TO: Planning Commission
FROM: Andrea Landers, Zoning Official
DATE: May 29, 2024
SUBJECT: 10-SPR-06-24 & 01-CSD-06-24 – Hemlock Park Site Condominiums (PIN: 0515951, 0515952, 0515953, 0515956, 0515957)

STAFF FILE REVIEW/ANALYSIS

File #: 01-CSD-06-24 (also 10-SPR-06-24)

Project/Application: Veridea Group, LCC is requesting a site condominium subdivision to be called Hemlock Park and is proposed to have 26 units. Please note, on April 24, 2024, a combination request and land division application has been conditionally approved for the proposed parcels as shown in the survey page of the site plan set.

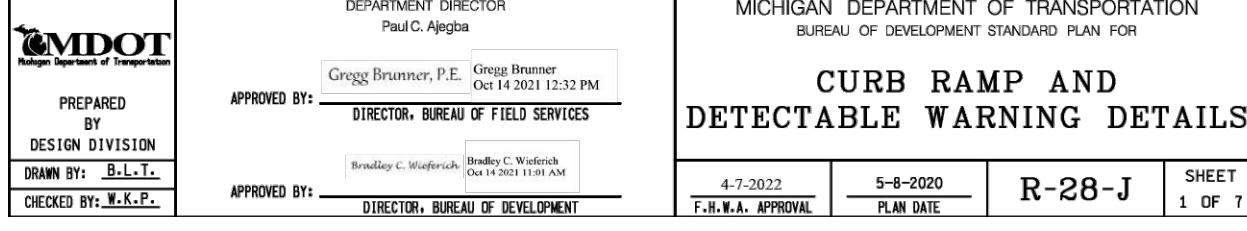
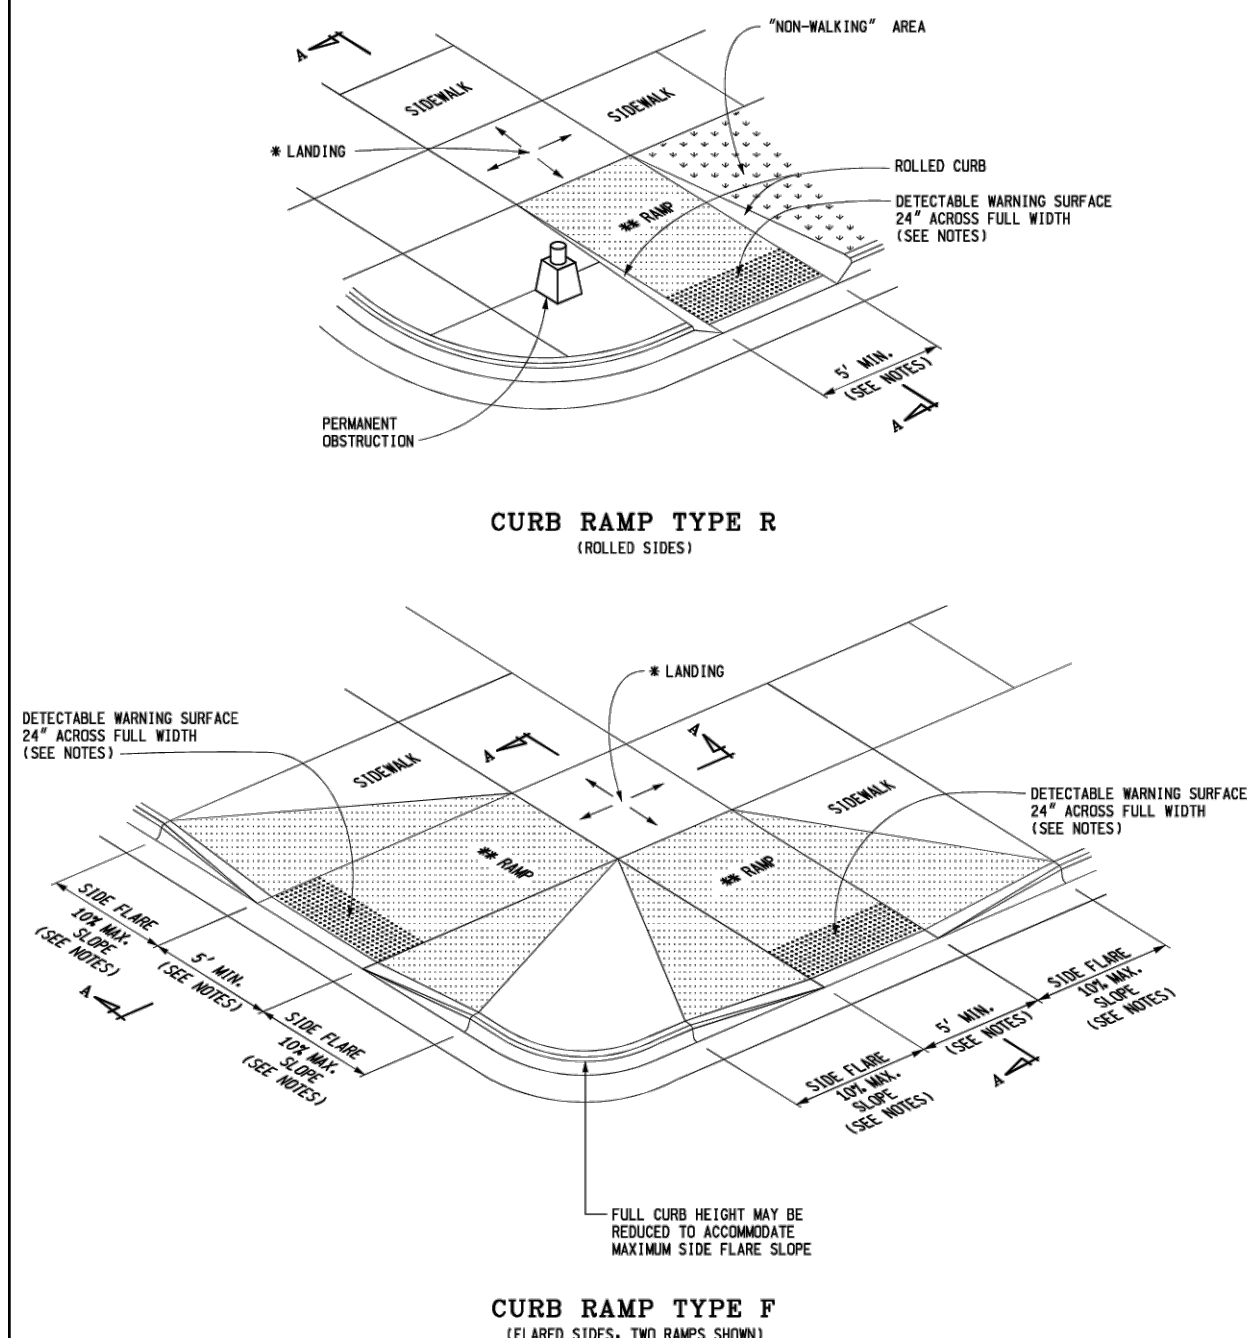
- C509: The proposed road cross section shows HMA being placed directly on top of the 12" layer of subbase modified. A 4" layer of 21A gravel should be placed between to allow for a grading surface. The subbase modified is made up of a 3" and smaller rock and is not easily shaped. This detail was missed in previous reviews of the road and utility plans. However, this was discussed with Veridea and Oberstar at a preconstruction meeting on 5/7/24 with the consensus that this modification needs to be made to allow for proper road construction.

- Engineering Department Comment: C509 our engineer updated it per comment.
 - C509: The proposed road cross section shows HMA being placed directly on top of the 12" layer of subbase modified. A 4" layer of 21A gravel should be placed between to allow for a grading surface. The subbase modified is made up of a 3" and smaller rock and is not easily shaped. This detail was missed in previous reviews of the road and utility plans. However, this was discussed with Veridea and Oberstar at a preconstruction meeting on 5/7/24 with the consensus that this modification needs to be made to allow for proper road construction.
- General Comments: There are no common elements other than the common area land (13.08 acres) at this time.
- There is no plan to allow for the subdivision of the site condominium units.
